# UNITED STATES PATENT AND TRADEMARK OFFICE

<b>Office Action Summary</b>	Application No. 10/780,320	Applicant(s) CAVENEY ET AL.	
	Examiner Philip Gabler	Art Unit 3637

## DETAILED ACTION

Thiede et al. '498 Figures 2-4

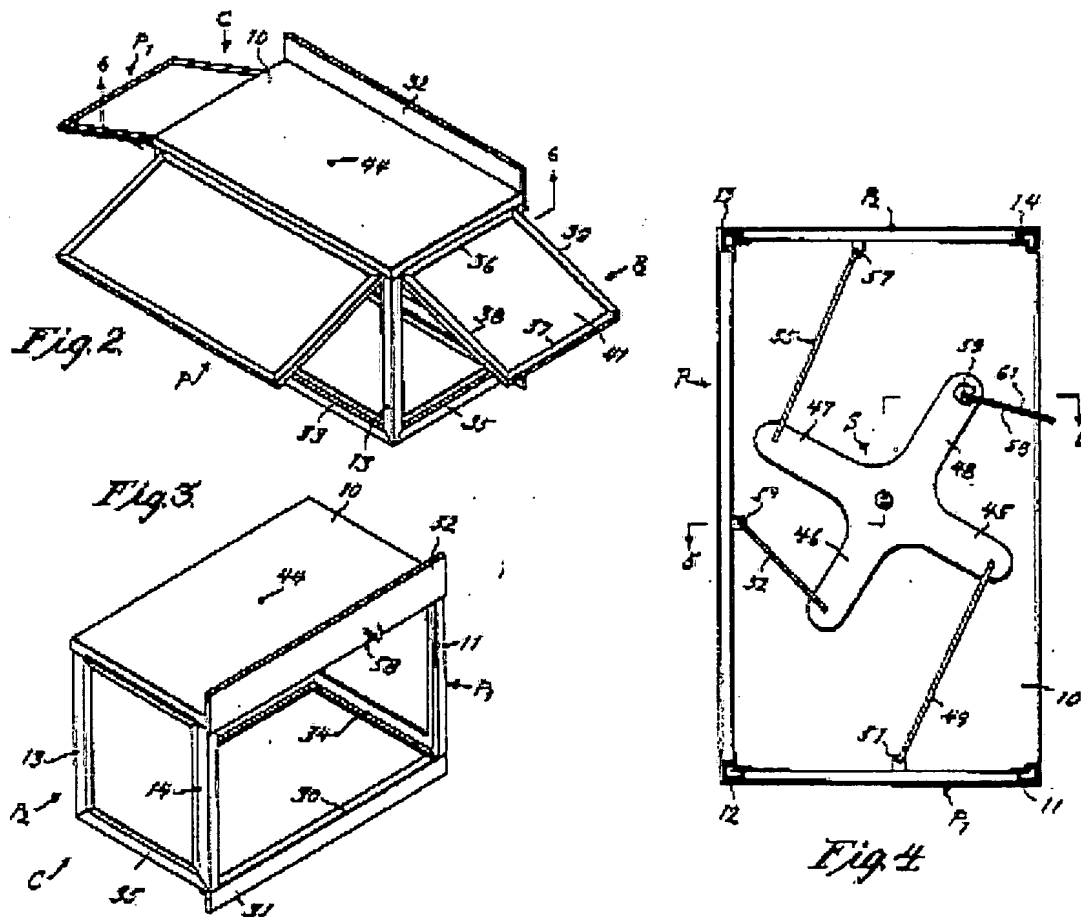
2. Claims 1 and 3 are rejected under 35 U.S.C. 102(b) as being anticipated by Thiede et al. (US Patent Number 3006498). Thiede (Figures 2-4) discloses a wall mountable cabinet comprising: a rear section (10-14, 31-35, etc.) having a top side (10), a bottom side (members 30, 33, 34, etc.), and a first side (formed by 11, 12, etc.) between the top side and the bottom side, the rear section including a cutout (space defined by members 12, 13, 33, etc.) extending from the first side along a portion of the top side, wherein the cutout is adapted to be capable of receiving a plurality of cables; and a front section (P) hingedly connected to the rear section at a pivot point (front edge of 10) adjacent the cutout, wherein the cutout is capable of allowing the plurality of cables to rotate about the pivot point when the cabinet is moved from a closed position to an open position (the opening and closing of front section, P, for instance).

3. Regarding claim 3, Thiede further discloses two side access panels (P1 and P2) hingedly connected to the front section (through mechanism S and links 49, 52, and 55).

Exhibit 1: Hansson '362 Figures 1, 2, and 4

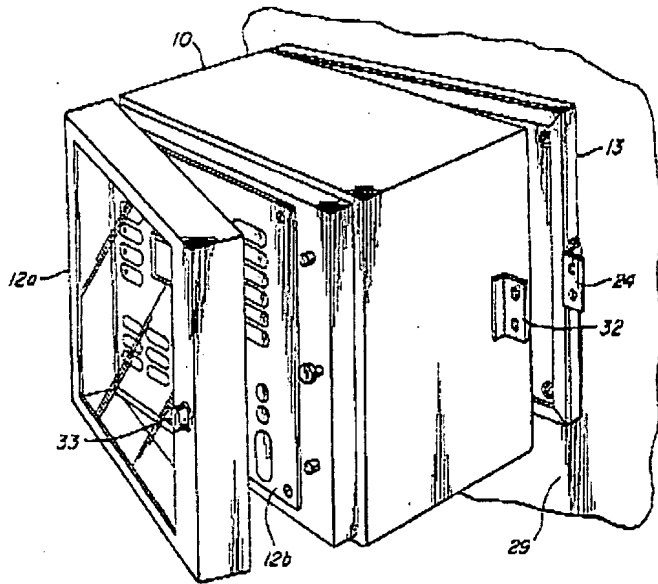
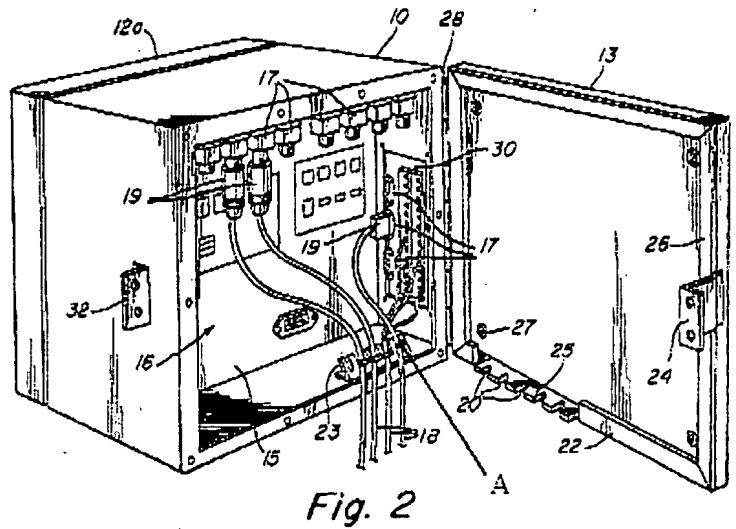
4. Claims 1, 4, 6, 7, 9, 11, 14, 17, 19, and 23 are rejected under 35 U.S.C. 102(b) as being anticipated by Hansson (US Patent Number 5568362). [Note that for the 35 USC 102(b) rejections in view of Hansson, Hansson's device is viewed in an inverted position as shown in Exhibit 2.] Hansson (Figures 1, 2, and 4) discloses a wall mountable cabinet comprising: a rear section (13) having a top side (at member 22), a bottom side (opposite member 22), and a first side (hinge side of 13) between the top side and the bottom side, the rear section including a cutout (at 20) extending from the

first side along a portion of the top side, wherein the cutout is adapted to be capable of receiving a plurality of cables; and a front section (10) hingedly connected to the rear section at a pivot point (28) adjacent the cutout, wherein the cutout is capable of allowing the plurality of cables to rotate about the pivot point when the cabinet is moved from a closed position to an open position (the movement of the front section about pivot point 28, for instance).

5. Regarding claim 4, Hansson further discloses a front door (12a) hingedly connected to the front section (see Figure 1), wherein the front door includes a transparent window (see column 1 lines 64-65).

6. Regarding claim 6, Hansson further discloses a slack cable manager (viewed as A in Exhibit 1) secured to a rail (23) mounted therein.

7. Regarding claim 7, Hansson further discloses a patch panel (30) secured to a rail (15) mounted therein.

8. Regarding claim 9, Hansson further discloses active equipment (17, 19) secured to a rail (15) mounted therein (via panel 30).

9. Regarding claim 11, Hansson discloses a wall mountable cabinet comprising: a rear section (13) having a top side (at member 22), a bottom side (opposite member 22), and a first side (hinge side of 13) between the top side and the bottom side, the rear section including a cutout (at 20) extending from the first side along a portion of the top side, wherein the cutout is adapted to receive a plurality of cables; and a front section (10) hingedly connected to the rear section (through hinge 28), the front section having a cable management ring (A, which points to a cable tie secured to tie bracket

23, the cable tie being viewed as a cable management ring) secured thereon, wherein the cable management ring is adapted to be capable of enclosing the plurality of cables, wherein when the cabinet is in a closed position, the cable management ring is vertically aligned with the cutout (as is clear in Figure 2, where a vertical cable, 18, passes through the cable management ring and is aligned to enter the cutout upon closure of the cabinet).

Ehrenfels '129 Figures 1, 2, and 5

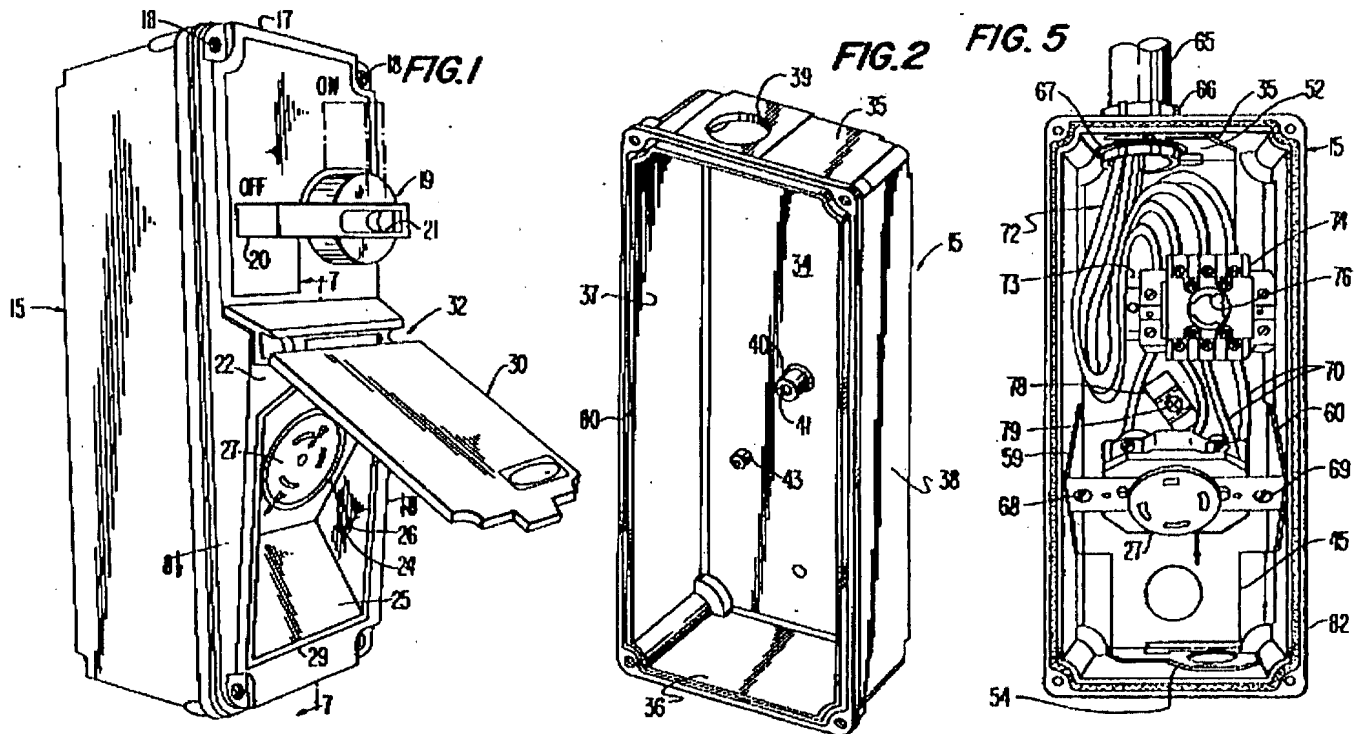
25. Claims 2 and 12 are rejected under 35 U.S.C. 103(a) as being unpatentable over Hansson in view of Ehrenfels (US Patent Number 5239129). Hansson discloses a wall mountable cabinet as recited in claims 1 and 11 as described above but does not disclose a duct positioned adjacent the cutout. Ehrenfels discloses a wall mountable cabinet with a duct (65) adjacent to a cutout (39). Accordingly, it would have been obvious to one of ordinary skill in the art at the time the invention was made to modify

Hansson's cabinet to include a duct positioned adjacent to the cutout as taught by Ehrenfels because this arrangement would protect cables routed through the cutout.

Nelson et al. '966 Figure 17

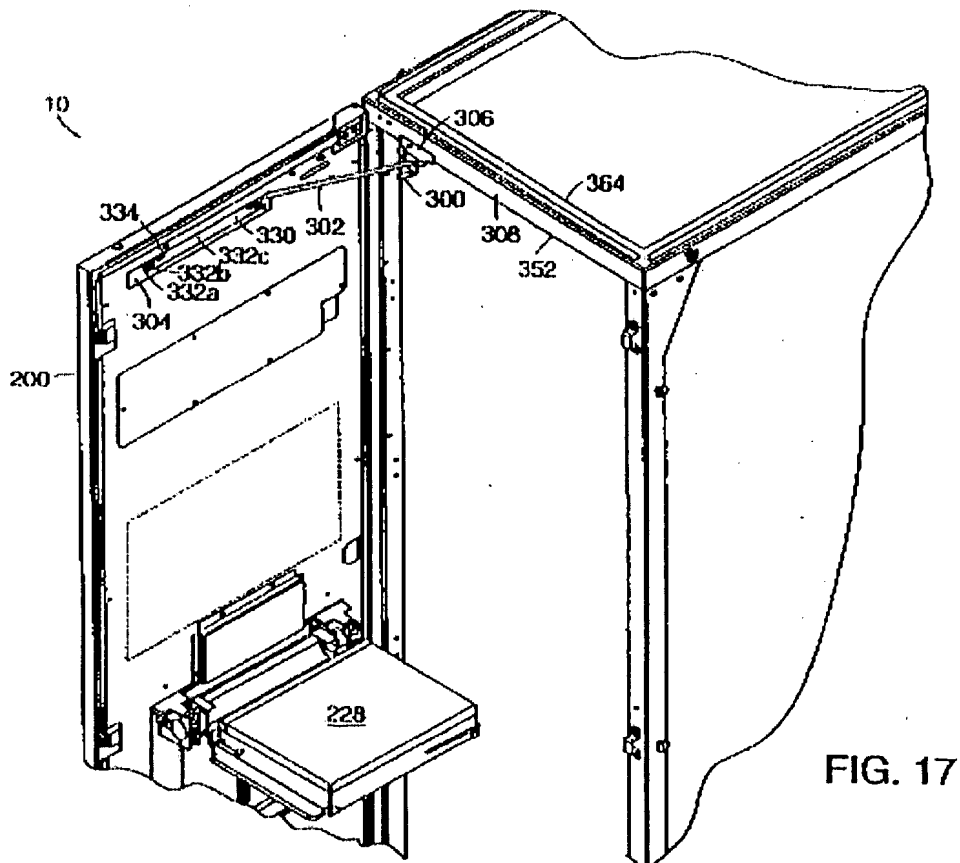
26. Claims 5 and 15 are rejected under 35 U.S.C. 103(a) as being unpatentable over Hansson in view of Nelson et al. (US Patent Number 6061966). Hansson discloses a wall mountable cabinet as recited in claims 1 and 11 as described above but does not disclose a rod which maintains the front section in an open position. Nelson (Figure 17) discloses a cabinet comprising a rod (302) which maintains the front section (200) in an open position about 90 degrees from the rear section (308). Accordingly, it would have been obvious to one of ordinary skill in the art at the time the invention was made to

modify Hansson's cabinet to include a rod to maintain the front section in an open position as taught by Nelson because this arrangement would facilitate access to Hansson's cabinet by providing a prop for the front section.

English et al. '233 Figure 1

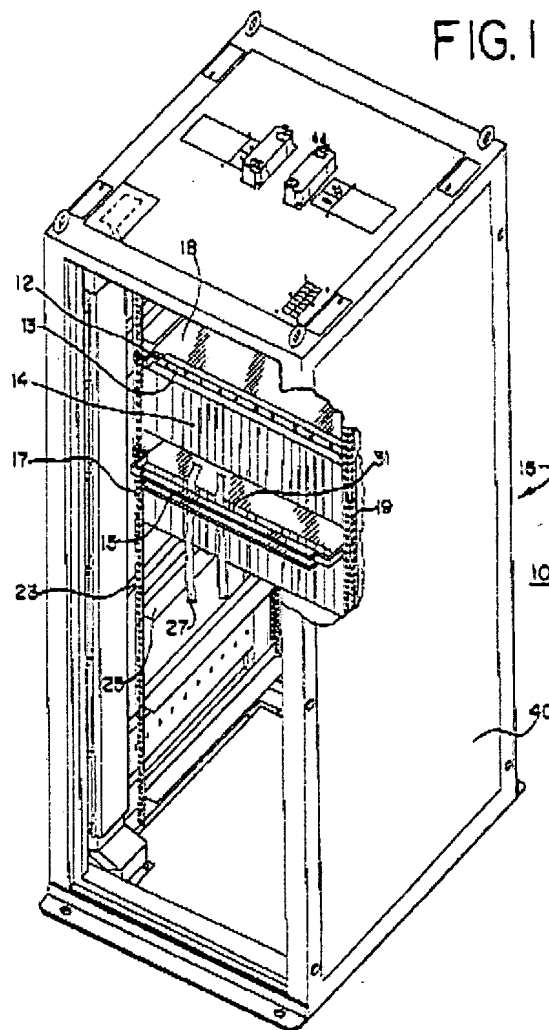
27. Claims 8, 10, 16, 18, and 22 are rejected under 35 U.S.C. 103(a) as being unpatentable over Hansson in view of English et al. (US Patent Number 6067233). Hansson discloses a wall mountable cabinet as recited in claims 1 and 11 as described above but does not disclose a horizontal cable manager secured to a rail. English (Figure 1) discloses a bar (12) mounted to a rail (17) intended for both cable

management use and mounting of electronic modules (see column 3 lines 59-62) and that is capable of supporting a slack cable manager, horizontal cable manager, patch panel or active equipment as is known in the art. Accordingly, it would have been obvious to one of ordinary skill in the art to modify Hansson's cabinet to include a cable manager or electronic component mount secured to a rail system as taught by English because this arrangement would provide more versatility to Hansson's cabinet while maintaining organization.

28. Regarding claims 10 and 22, Hansson discloses a wall mountable cabinet as recited in claims 4 and 14 as described above but does not disclose an adjustable rail. English discloses a rail (12) that can be adjusted (via holes 23) to various positions within a cabinet (10). Accordingly, it would have been obvious to one of ordinary skill in the art at the time the invention was made to modify Hansson's cabinet to include an adjustable rail as taught by English because this would allow greater flexibility as to what could be mounted in his cabinet.

Erickson '319 Figure 1

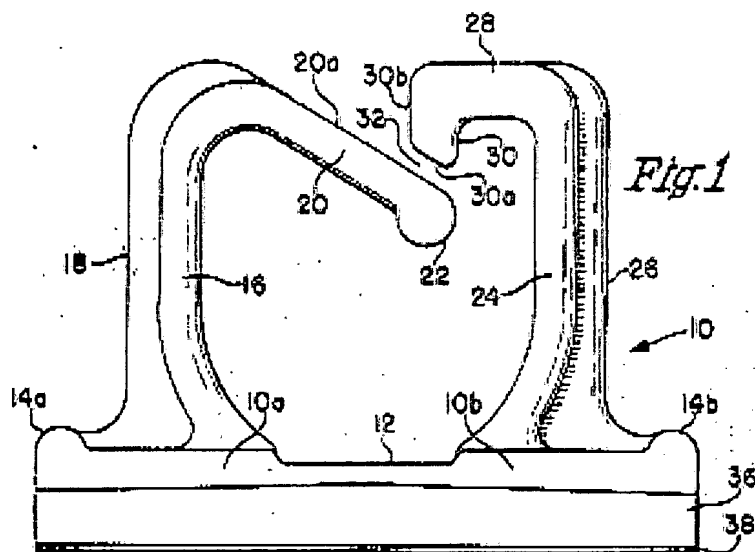
30. Claims 21 and 24 are rejected under 35 U.S.C. 103(a) as being unpatentable over Hansson in view of Erickson (US Patent Number 3659319). Hanson discloses a wall mountable cabinet as recited in claim 11 as described above but does not disclose a cable management ring with substantially L-shaped arms. Erickson (Figure 1) discloses a wire management clip with first (16 and 20) and second (24 and 28) substantially L-shaped arms having distal portions (20 and 28) oriented substantially 90 degrees from substantially linear portions (16 and 24), wherein the arms are formed of a material and construction capable of providing rotation (i.e. plastic; see column 2 lines 17-18) about the axis of their linear portions. Accordingly, it would have been obvious to one of ordinary skill in the art at the time the invention was made to modify Hansson's cable management ring to include substantially L-shaped arms as taught by Erickson because this arrangement would make securing and removing cables from the ring more efficient.
